Report of the Highway 407 Safety Review Committee

1. PROJECT INFORMATION

1.5 The safety review committee mandate The mandate of the PEO Highway 407 Safety Review Committee, as adopted by the PEO Executive Committee, is presented below.

Fig 5.4. Typical Cross-Section Basic Six-lane Configuration

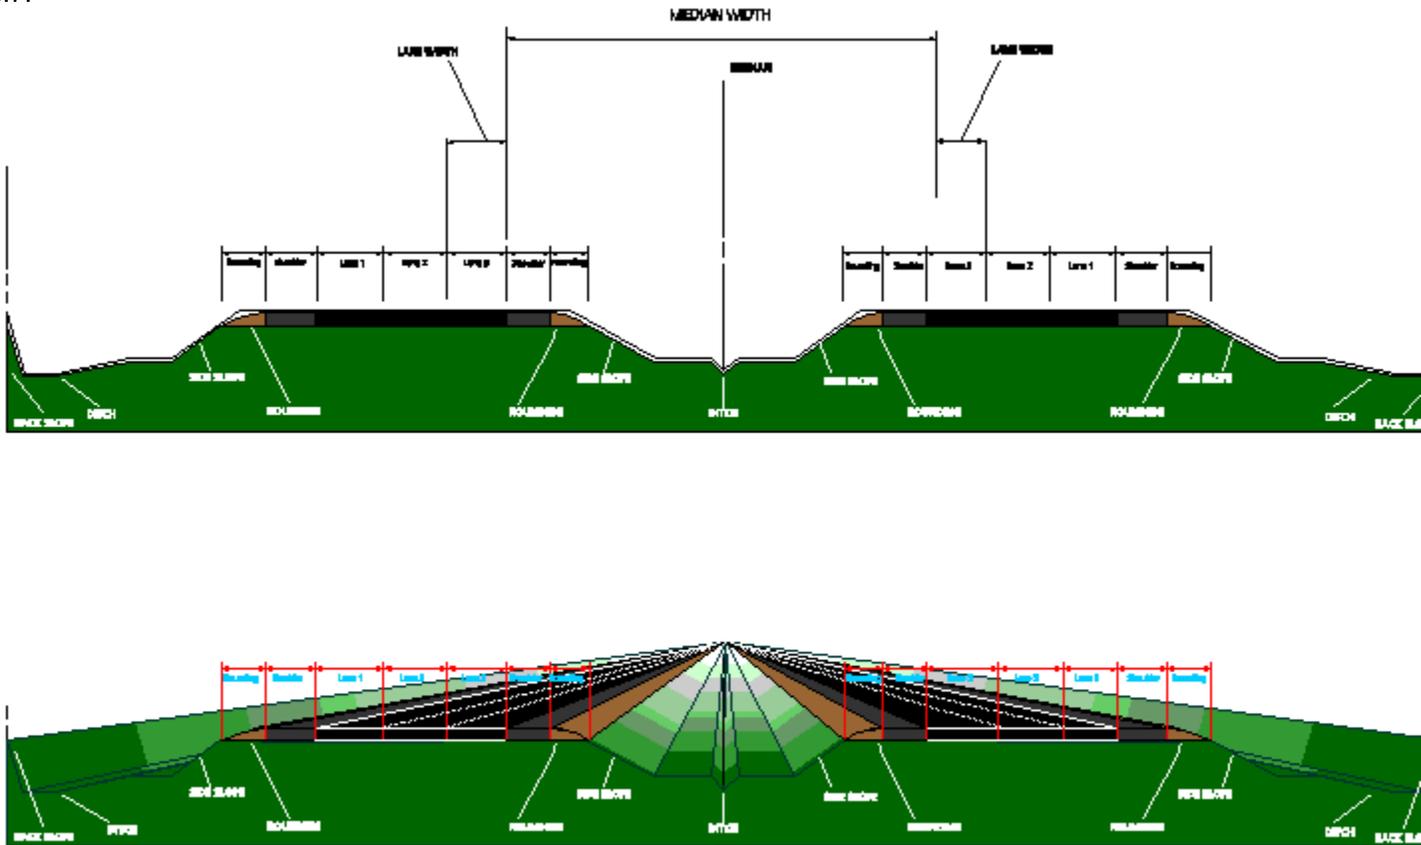
Do not meet current standards; refer to Section 6.7.

Figure 6.1. Median shoulder measurement on Highway 407

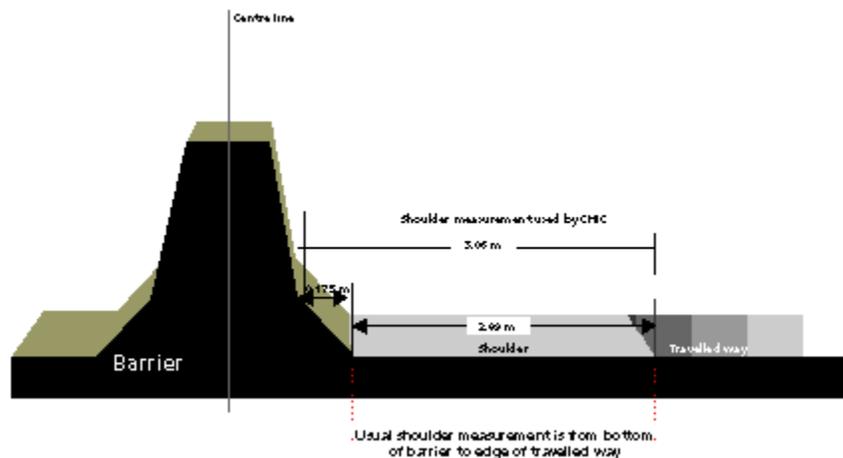
- *Were prevailing standards met with respect to median width?*

The pertinent standards here are those of median width, which in the ultimate stage should be 7.5m (Ref. 1, D6.2.2), the shoulder width, which is normally 3.0m (Ref. 1, D5.3), and the 10m distance to obstacles that do not require a barrier. All these standards were met.

To meet the shoulder-width standard, interpretation of what is meant by "shoulder" was required. The dimension of a shoulder in engineering drawings is generally the horizontal distance from the edge of the travelled lane to the bottom of the barrier. Here, it is redefined to be the horizontal distance to some point on the tapered portion of the barrier (see Figure 6.1). This redefinition enabled the 3.0m width standard to be met. This illustrates how a design process can be distorted to meet minimum standards. The committee does not condone this practice. However, the committee does not think that a few centimetres shortfall in shoulder width makes much of a difference to safety.

Figure 6.2. Shoulder rumble strips

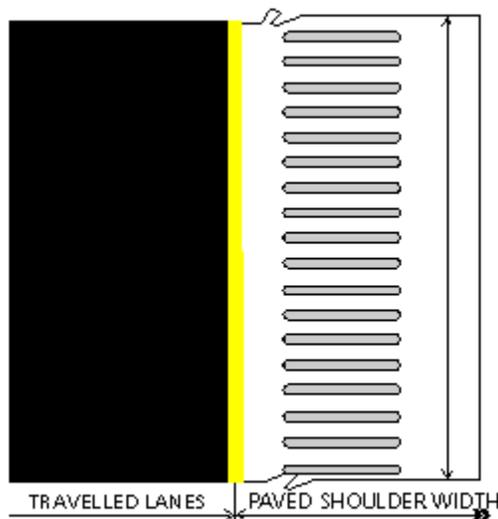
The width of the median is now set. One can attempt to diminish the future frequency and severity of median collisions by several means: protection of the masts, reshaping of the existing cross-section to be more forgiving, safety attention to the hydraulic structures in the median and installation of shoulder rumble strips (see Figure 6.2).

1. Examine the potential of installing some type of inertial device (barrier) around each mast.
2. Examine the potential of reshaping the median, and in particular the V- ditch in its middle.
3. Examine the potential of shoulder rumble strips.
4. Examine the potential for improving the safety aspects of the hydraulic structures in the median.

Figure 6.7. Median Barrier Warrant Guide

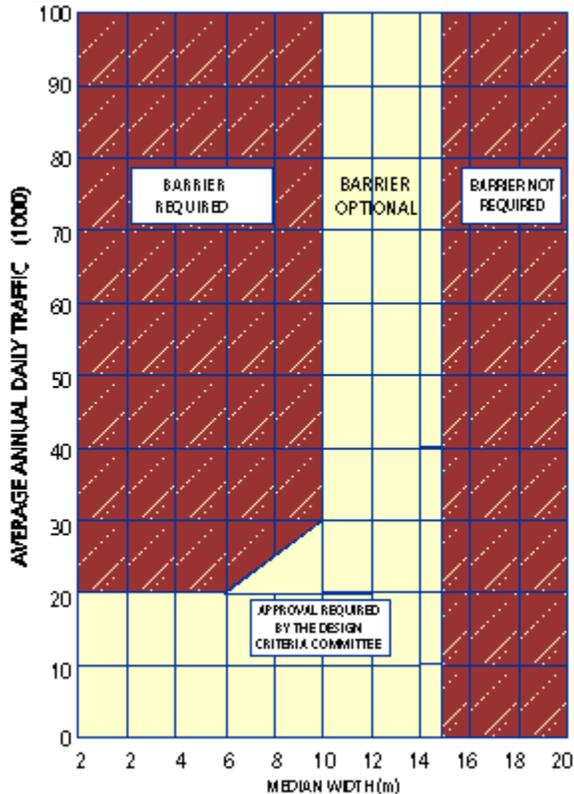
On cross-median accidents, the original decision not to provide a barrier was based on the "Median Barrier Warrant Guide" of the Ontario Roadside Safety Manual (Ref. 3) reproduced in Figure 6.7. It shows

the conditions of traffic flow and median width under which a median barrier is deemed warranted. By the warrant, medians wider than 15m do not require a median barrier. Since the median on Highway 407 is 22.5m in width, by the manual a median barrier is not warranted.

The median barrier warrants used in Ontario are very similar to those in the Canadian standards (Ref. 4) which, in turn, are very similar to the warrants used in the United States. In 1960, a median barrier was deemed unwarranted in the U.S. if the median was wider than 12m. This limit has fluctuated over time, however; since 1977 it has been at 15m. For medians that are between 10m and 15m wide, the installation of a median barrier is deemed optional.

If a median barrier were to be implemented now, it would largely nullify the concern about the obstacles that the high-mast light standards now present. However, it would result in the replacement of one obstacle by another one. The barrier would be a continuous obstacle. The question is whether the safety consequences (collisions with light standards, overturns in the ditch and cross-median accidents) of the median as it now exists are worse than the consequences of a continuous median barrier.

Our own analyses show that, considering all safety consequences, to build a median barrier now would not be cost-effective and would be detrimental to safety.
